Product Change Notification

Change Notification #: 112326 - 00
Change Title: Intel® Server System P4308CP4MHGC
PCN 112326-00, Product Design, Label
Update BIOS/ME Firmware, Server Side
Cover and Package Regulatory Label with
Perchlorate Statement
Date of Publication: June 3, 2013

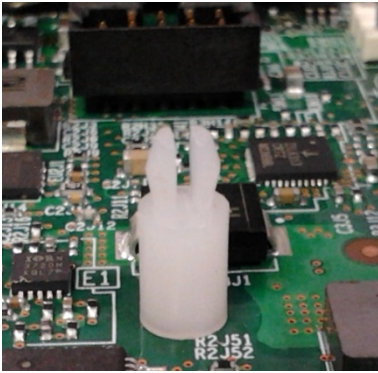
3. A plastic stand-off will be pre-installed on the server board. Users can install an eUSB SSD device on the stand-off.

The picture below shows what the stand-off looks like:

The picture below shows the stand-off pre-installed on the server board:

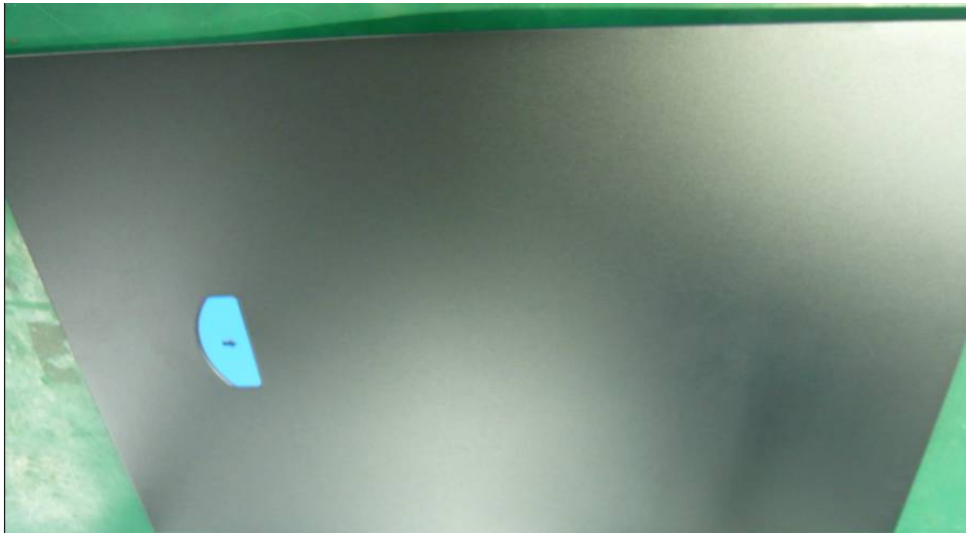
4. A side cover handle will be added to improve the ease of cover removal. See the Post change pictures below for an illustration of the change.

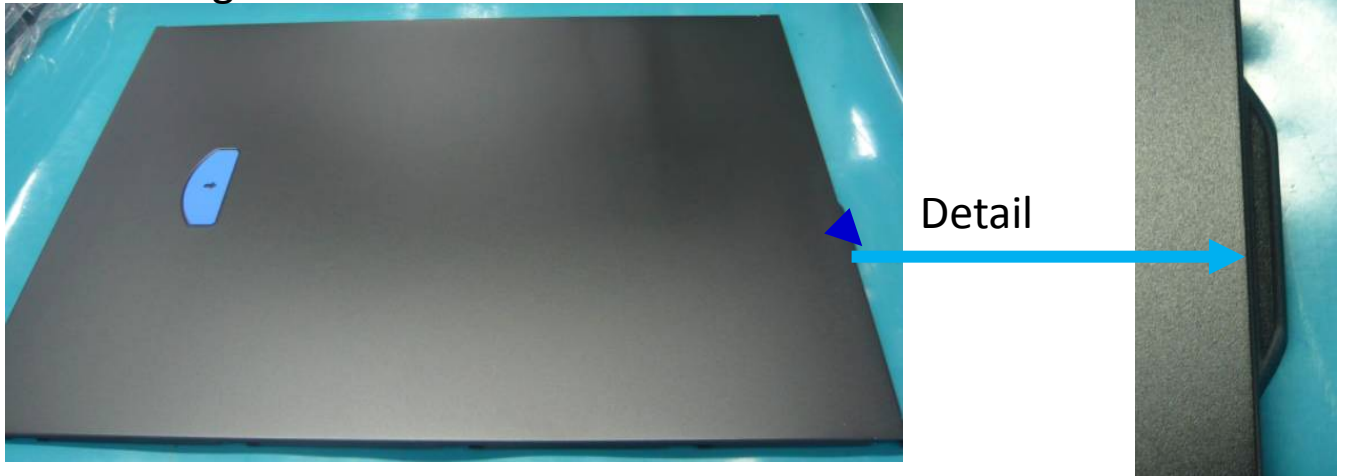
5. As part of Intel's efforts in environmental responsibility to eliminate excess materials for disposal, Intel will no longer be including the piece of paper with the California PERCHLORATE notification. Instead Intel will be including the California PERCHLORATE notification on an existing safety label. See below picture. See below picture:
